Fax Transmittal

New York State
Department of Transportation
Traffic Engineering & Highway Safety

From: Howard McCulloch
To: Woodin, David
Date: 12/5/02 9:58AM
Subject: Fwd: RE: Roundabout Task force

Figure 3B-28. Examples of Markings for Roundabouts with Two-Lane Approaches

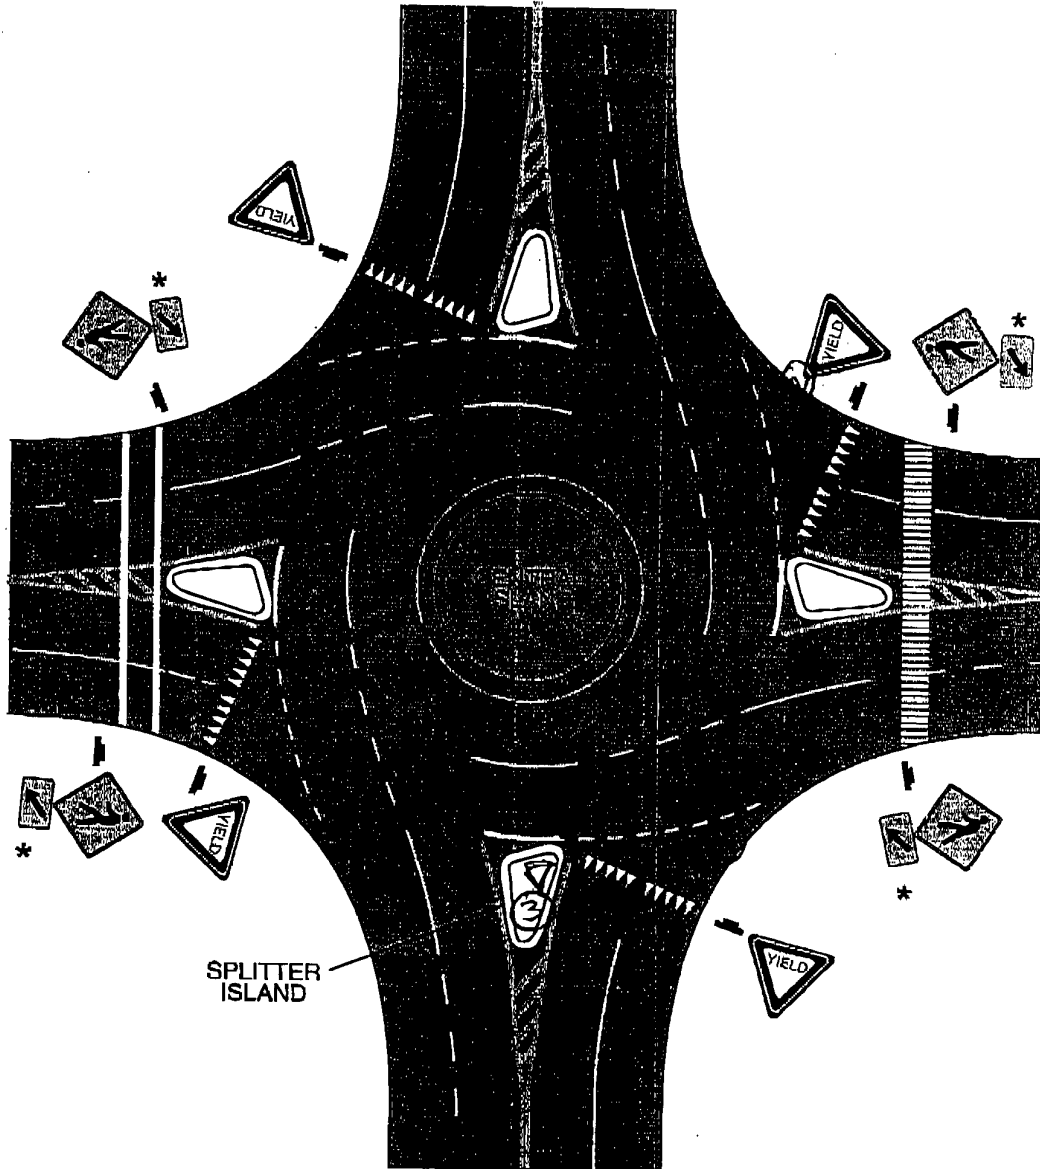
6) "Cat Trax" as optional

- 1) Continue solid line to dashed line
- 2) stagger Shark's teeth
- 3) Yield sign in splitter as optional
- 4) Arrows
- 5) Even though it is for markings, a more realistic geometric limit may be beneficial.

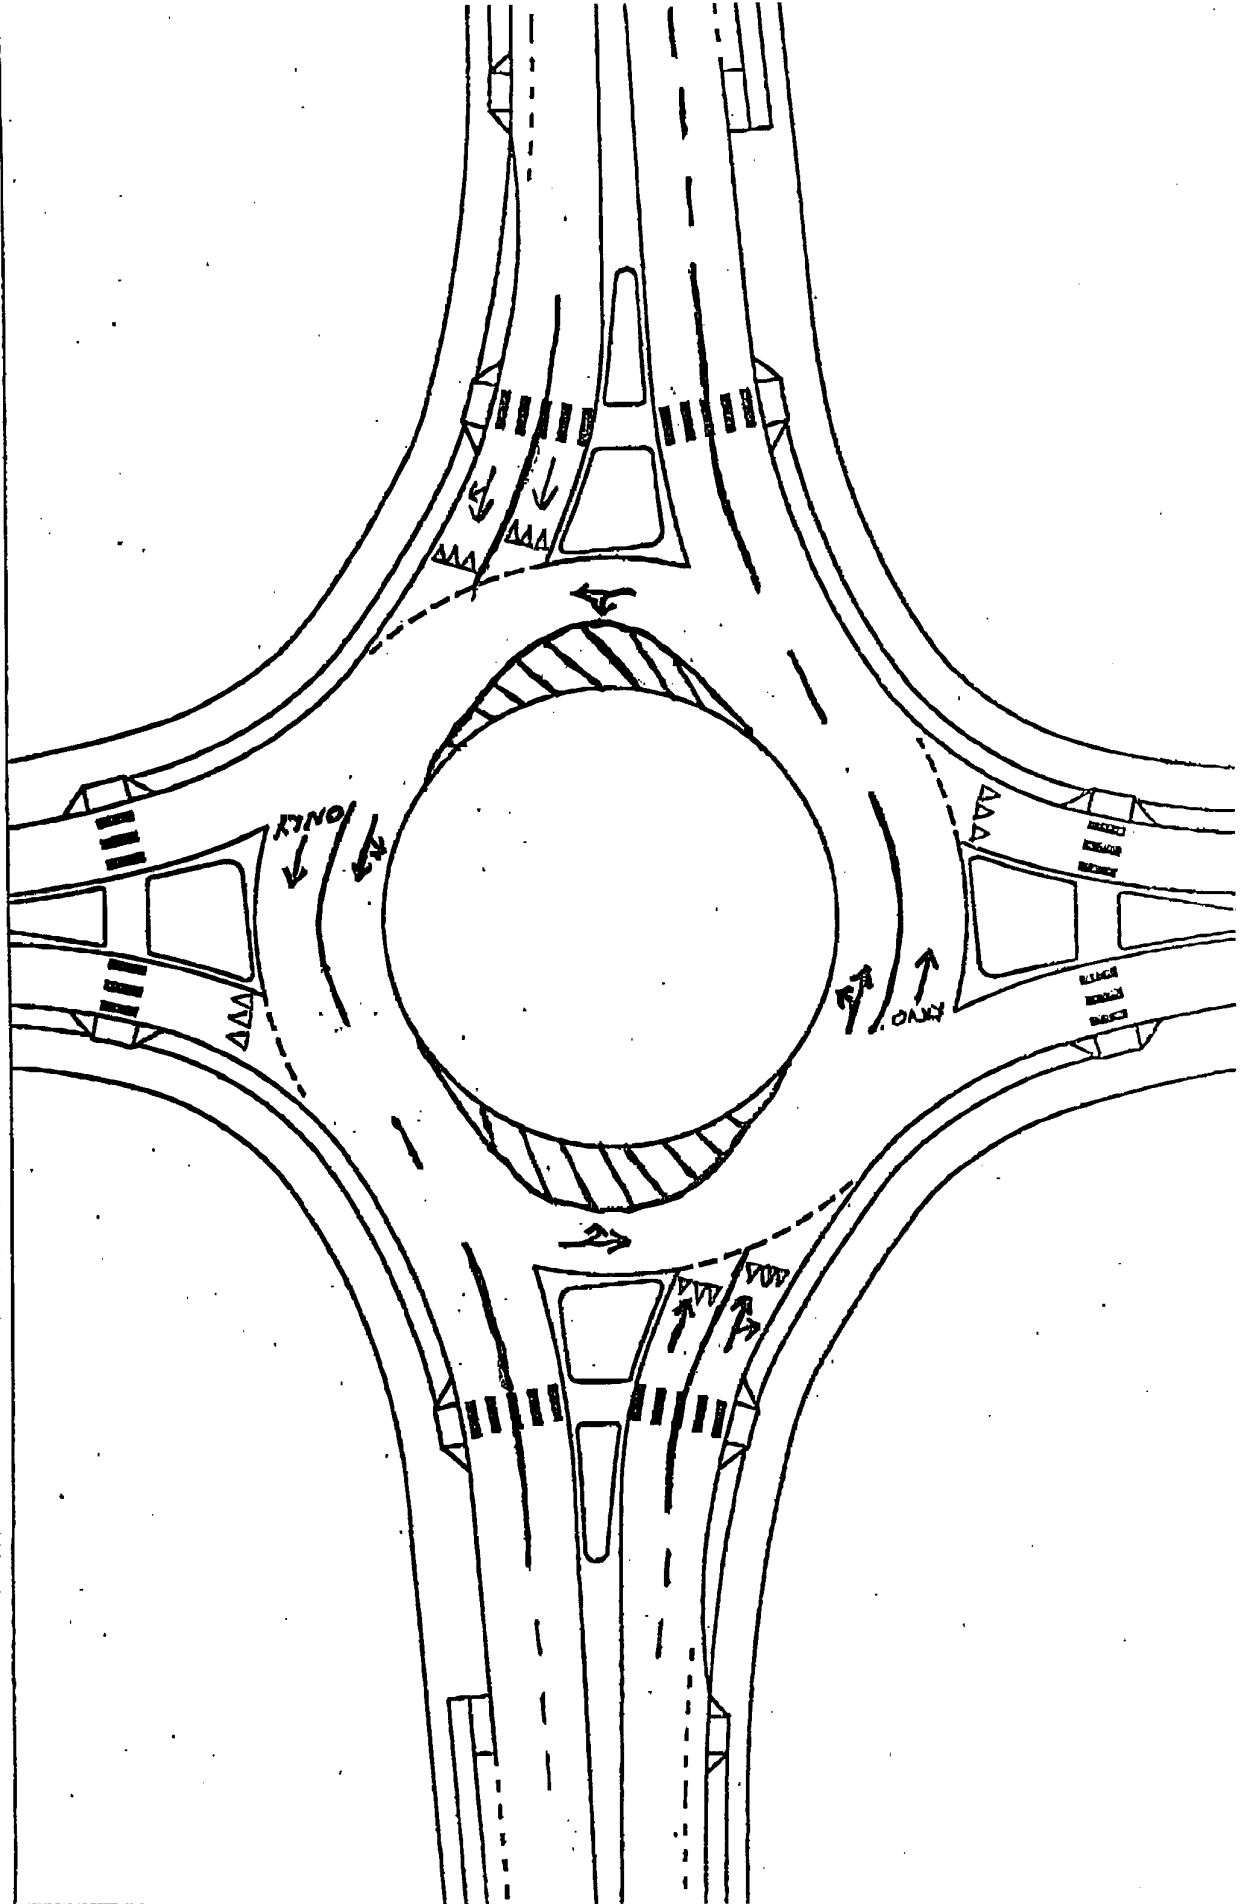
- 1) Spiral to outside is preferred but can be done to inside.
- 2) A thru/left arrow would be preferred if allowed.

Spiral on left side is favored (to the outside).

Left arrows on approach would be preferred if allowed.
